2014 - 2015 Corvette: Service Bulletin: Creak or Snap Noise Above Windshield from Removable Roof Lift Off Panel While Driving

GM Bulletin No.: #15-NA-016

Date: September 30, 2015

MODELS: 2014 - 2015 Chevrolet Corvette

- (1) Example of a bad front locating pin.
- (2) Example of a good front locating pin.

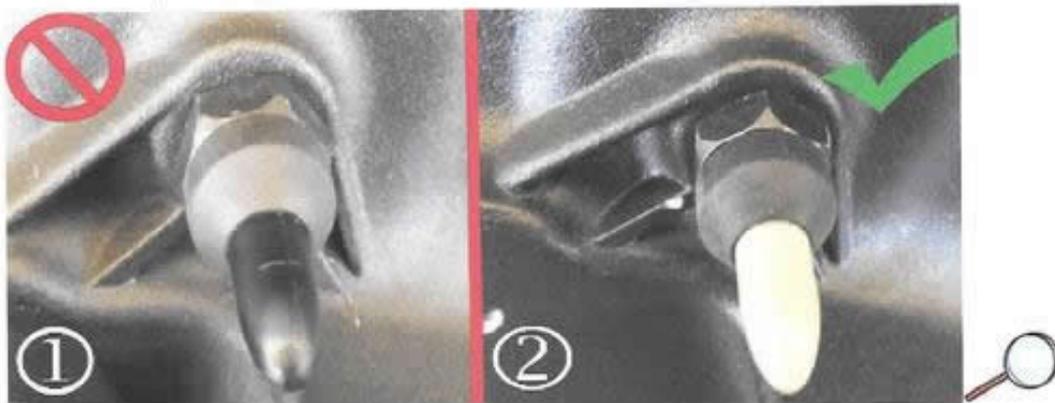
CAUSE: This may be caused by a stick-slip condition between the front latches against the strikers and the front locating pins to the locating cup in the strikers.

If you encounter a vehicle with the above concern, replace both the front roof lift off panel strikers and both front locating pins. Refer to Roof Lift Off Panel/Window Front Striker Replacement and Removable Top Locating Pin Replacement in SI.
